From: Margie Jacobs <margie@thjarch.com>
Sent: Monday, July 11, 2016 3:06 PM
To: 'Greg Meegan'; Jim Powell; Jessica Walker
Cc: Jamshid Baradaran; Mark Arnold; Louis Weckerling; John Kissell; lisa@thjarch.com
Subject: RE: Arts Place Extra - Retro Fit Roof Drain

From: Margie Jacobs <margie@thjarch.com>
Sent: Thursday, October 06, 2016 5:21 PM
To: 'Greg Meegan'; Jim Powell; Jessica Walker
Cc: 'Lisa Grober'
Subject: RE: Gov't Center Fire Escape Roof
Attachments: Fire Escape Siplast Parapro Details 10-6-16.pdf

From: Greg Meegan [<mailto:gmeegan@tri-stateservice.com>]
Sent: Thursday, October 06, 2016 1:05 PM
To: 'Margie Jacobs' <margie@thjarch.com>
Cc: 'Lisa Grober' <lisa@thjarch.com>
Subject: Gov't Center Fire Escape Roof

PARAPRO MEMBRANE SYSTEM

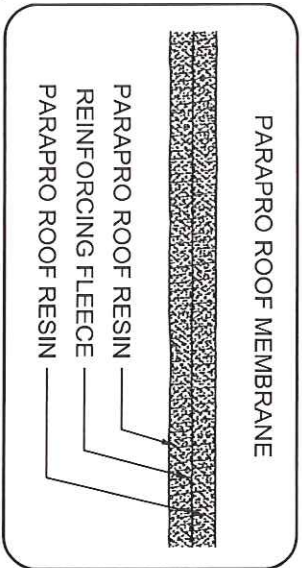
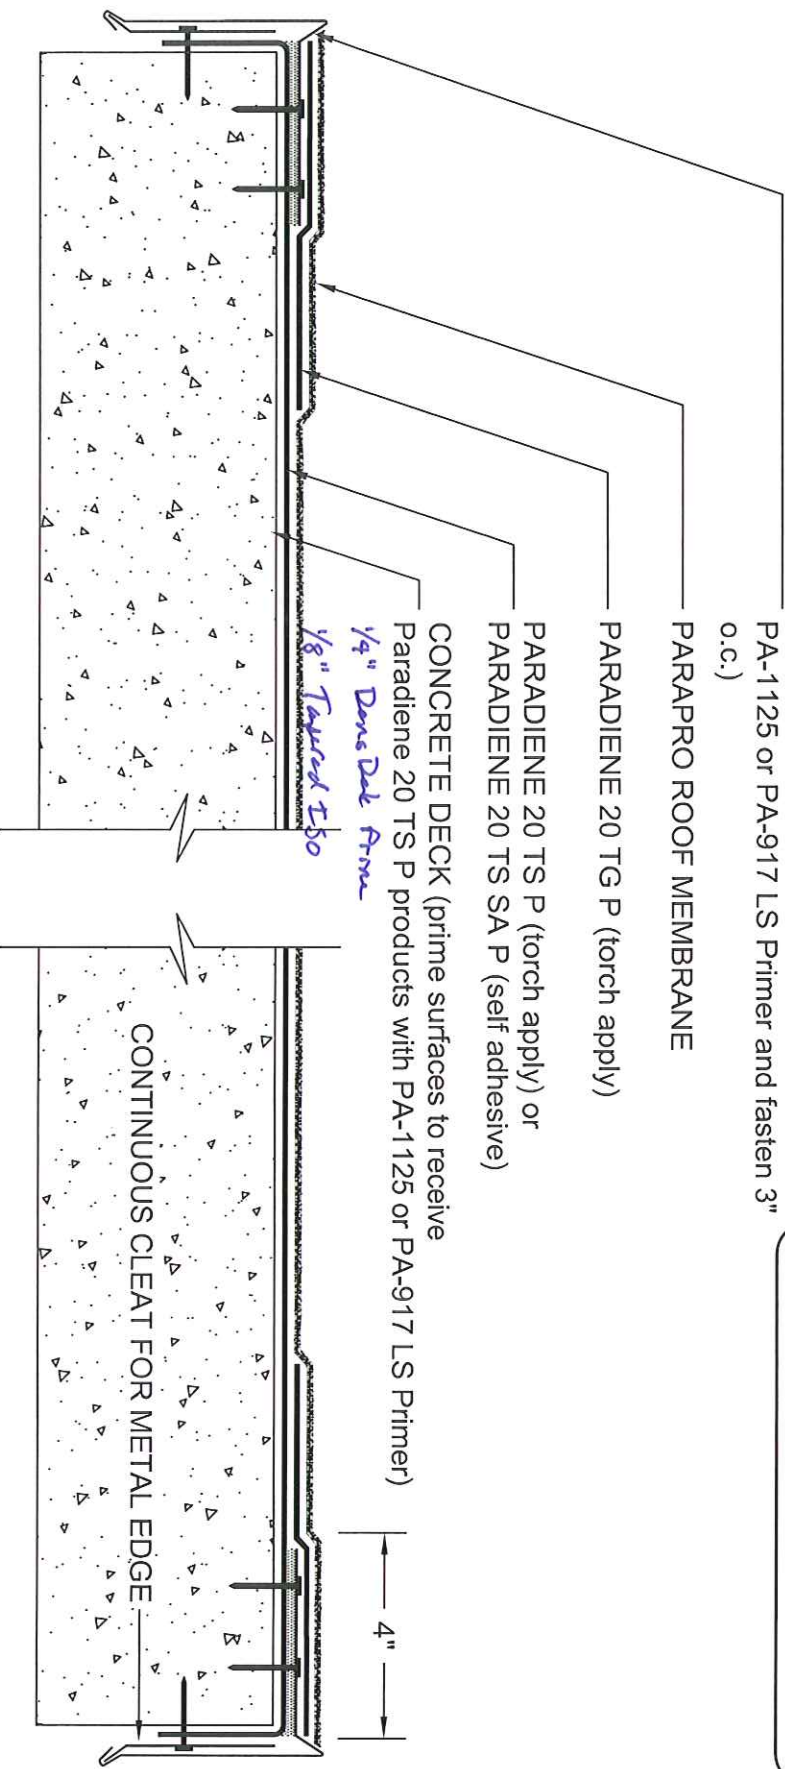
As we've discussed removing the existing roof on the Gov't Center fire escape platform and installing a new Siplast roof system is necessary.

Remove the existing roof and safety screen, dry and prepare the deck before setting 1/8" tapered ISO in low rise adhesive, 1/4" Densdek prime in low rise adhesive, Siplast's P20 SA Base Sheet, followed by Siplast's Parapro Roof Membrane. Additionally, metal edge will be installed around the perimeter to cover the existing vertical wall flashing. If the existing wall height will allow, we will install a reglet mounted two piece wall flashing. If the existing wall height does not allow, we will work with Siplast on a detail that meets their 20 year roof warranty specification.

Jim / Jessica: I recommend approval of Tri-States request for \$5,990,00 to perform the additional work enumerated in his message below.
